State of Washington
DEPARTMENT OF FISH AND WILDLIFE

SUBJECT: WDFW COMMENTS ON SE-20-00003 BROWN & JACKSON

Thank you for the opportunity to comment on the proposed grading permit and SEPA for the Brown & Jackson Storage Ponds project near Parke Creek. The Washington Department of Fish and Wildlife (WDFW) is familiar with this area and nearby critical areas that should be considered as part of this review and determination process.

Figure 1: Image taken from Kittitas County’s COMPAS mapper, demonstrating four mapped watercourses (three Type 2 streams and one Type 9) in addition to the Kittitas Reclamation District canal and a potential wetland) on the subject parcel.

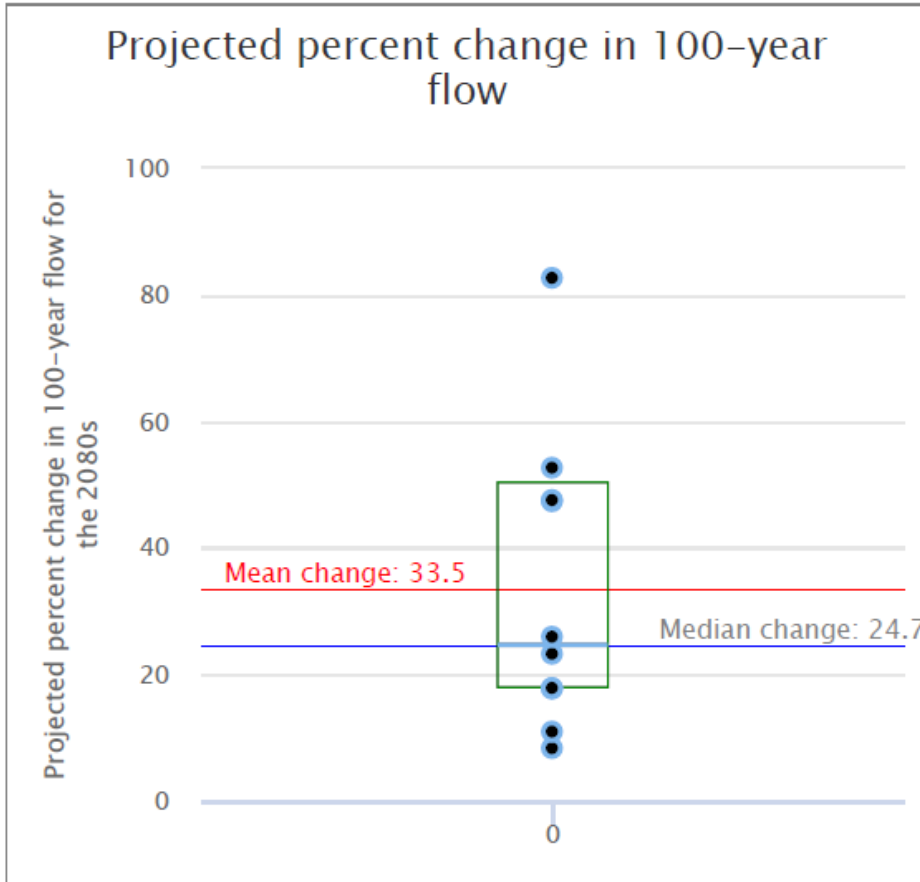
- The County’s online COMPAS mapper correctly displays Parke Creek, the seasonal stream referenced in the application materials and another seasonal stream that enters the property just south of the location of the proposed southern pond. There is another Type 9 stream that is shown on the COMPAS maps in the south east portion of the parcel as well (Figure 1). Each of these streams and their associated riparian ecosystems are FWHCAs and they are also displayed on the United States Fish and Wildlife Services online *National Wetland Inventory Wetland Mapper*.

- Multiple maps, including the County’s COMPAS mapper, show a potential 1.3-acre freshwater emergent wetland on the property southwest of the proposed ponds yet there is no mention of this potential wetland within the application materials available for review.

WDFW recommends that a qualified professional identify all of the critical areas, the potential impacts (including cumulative), and proposed mitigation measures for this proposal. One such mitigation measure could include permanent protection of the approximately 67 acres of shrubsteppe habitat that is not planned for construction of the ponds or land application.
